## SYDNEY NORTH PLANNING PANEL COUNCIL ASSESSMENT REPORT

<b>Panel Reference</b>	PAN-323210
<b>DA Number</b>	Mod2023/0201
<b>LGA</b>	Northern Beaches
<b>Proposed Development</b>	Modification of Development Consent N0440/15 granted for the subdivision of land and the construction of a residential development incorporating 81 dwellings and associated civil works and landscaping.
<b>Street Address</b>	Lot 1 DP 5055, 8 Forest Road WARRIEWOOD NSW 2102
<b>Applicant/Owner</b>	The Trustee for Forest Road Unit Trust Jubilee Developments Pty Ltd 8 Forest Road Pty Ltd
<b>Date of DA lodgement</b>	12/05/2023
<b>Number of Submissions</b>	1
<b>Recommendation</b>	Approval
<b>Regional Development Criteria (Schedule 7 of the SEPP (State and Regional Development) 2011)</b>	Section 4.56 Modification Application to a Regionally Significant Development pursuant to Schedule 7 Clause 2
<b>List of all relevant s4.15(1) (a) matters</b>	<ul style="list-style-type: none"> <li>• Environmental Planning and Assessment Act 1979;</li> <li>• Environmental Planning and Assessment Regulations 2021;</li> <li>• State Environmental Planning Policy (Building Sustainability Index: BASIX) 2004;</li> <li>• State Environment

**Figure 2 - Building Height non-compliance**

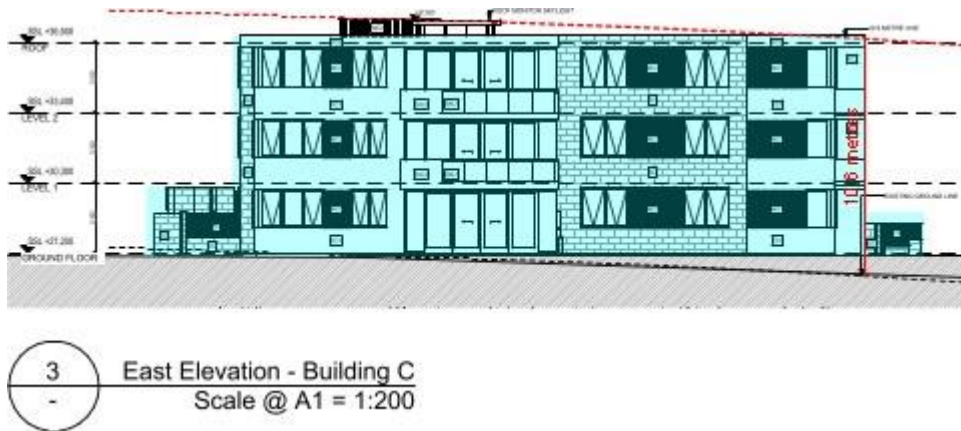
Development standard:	Height of Buildings
Requirement:	10.5m
Approved	10.7m (measured to approved lift overrun)
Proposed:	10.6m (facade alterations)
Percentage variation to requirement:	0.9% (0.1m)

Notwithstanding that Clause 4.6 does not apply to Section 4.56 modification applications, the merits of the variation have been assessed with regard to the objectives of the height of buildings development standard and the underlying objectives of the R3 Medium Density Residential zone. The assessment has also taken into consideration the relevant tests of the recent judgement contained within *Initial Action Pty Ltd v Woollahra Municipal Council* [2018] NSWLEC 118.

**Figure 3 - Section through townhouse 10**

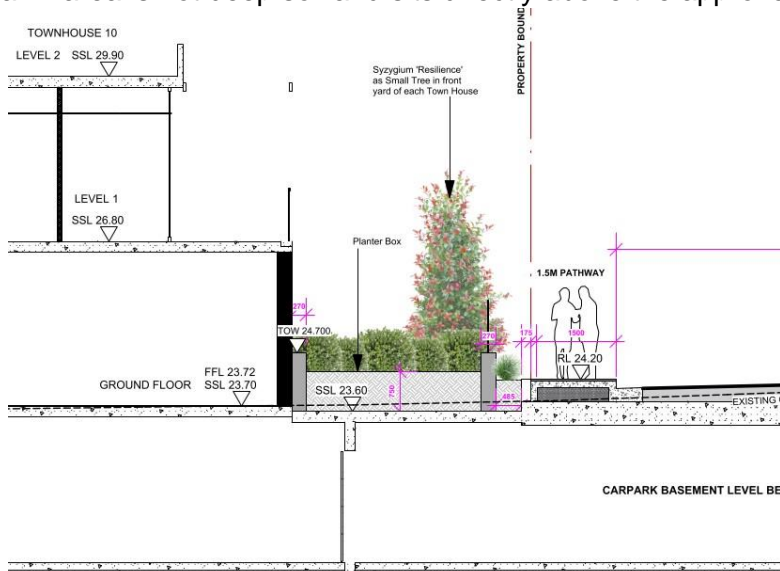
The application proposes to change the approved lawn area to the front of the townhouses to decking. The control, which requires at least 50% of the front setback area to be landscaped while not strictly applicable in this circumstance given that all dwellings are part of one lot, is intended to ensure adequate landscaping to the front of residential development to offset or soften built form. The existing lawn area is not deep soil and sits directly above the approved basement, as pictured below.

**Figure 4 - Proposed decking to the front of the approved townhouses**

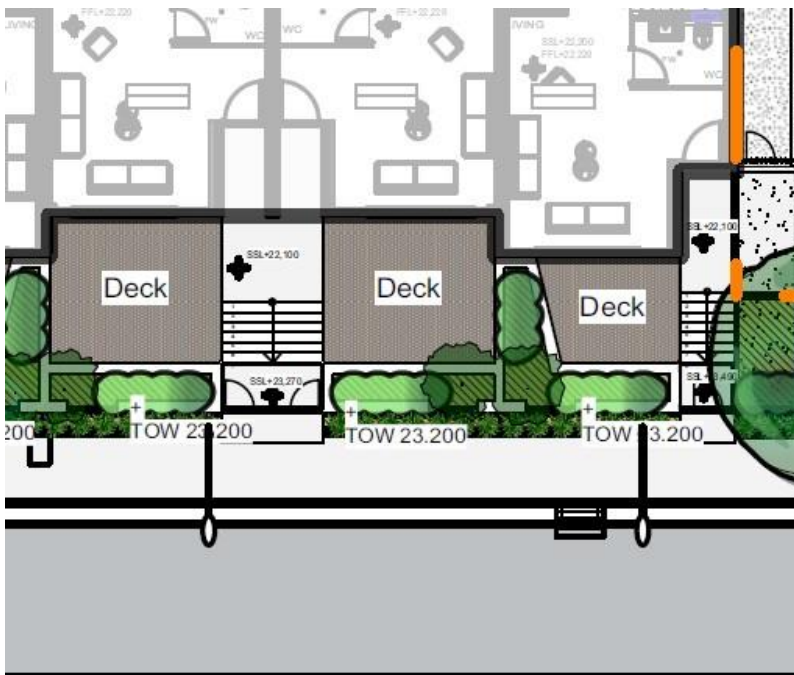
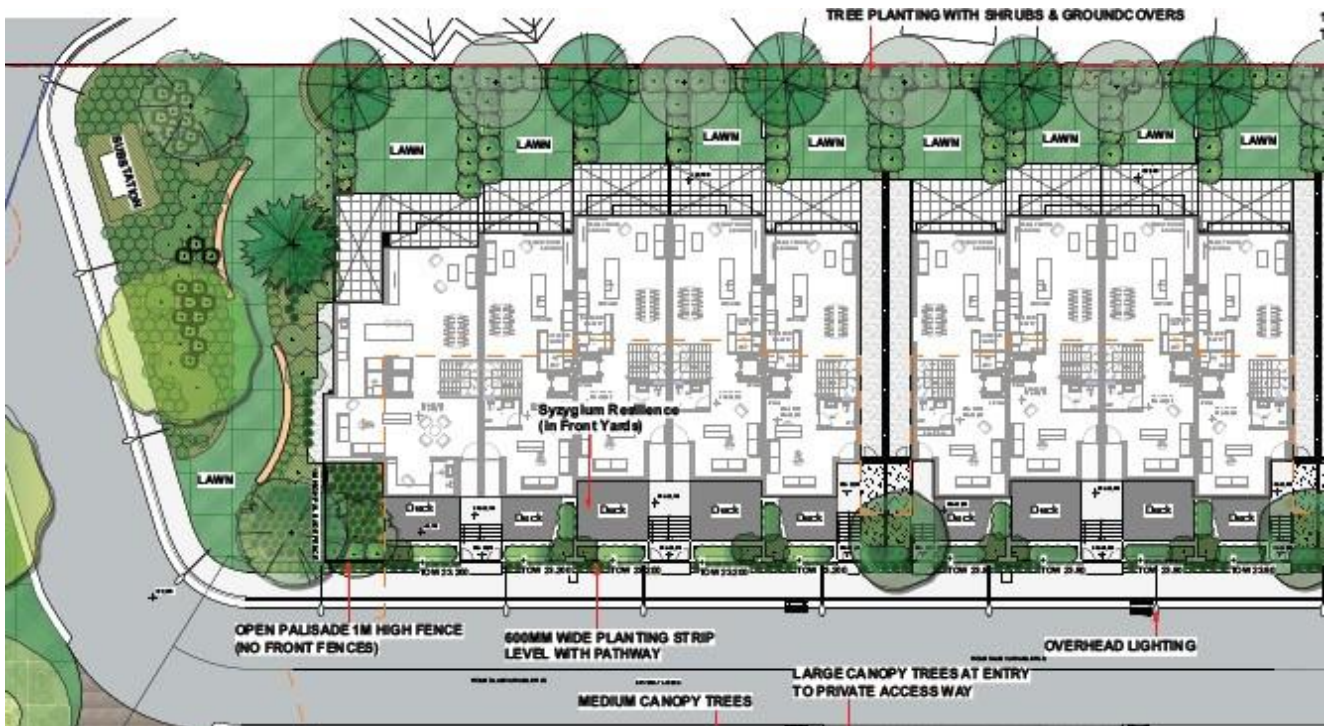
The decking for each townhouse will allow for an additional living area for occupants. This area will be screened by the planter boxes (minimum depth 1m) to the front and side of each townhouse. However, given the scale of the decks and limited size of the planter boxes, there is limited opportunity for

landscaping within the front setback, which fails to meet the first outcome above. The deck would remove opportunity for landscaping within the front setback area which would assist in visually reducing the built form of the two storey townhouses. The following condition of consent has been imposed to increase the level of landscaping to the front of the townhouses while still allowing for a reasonable sized deck to be utilised as a secondary living area.

*a) Where decks are proposed in the front setback, the setback to the deck from the front boundary will be a minimum 2.5 metres with the landscaping planter boxes increased in size and planted out with native species.*

- a) Where decks are proposed in the front setback, the setback to the deck from the front boundary will be a minimum 2.5 metres with the landscaping planter boxes increased in size and planted out with native species.
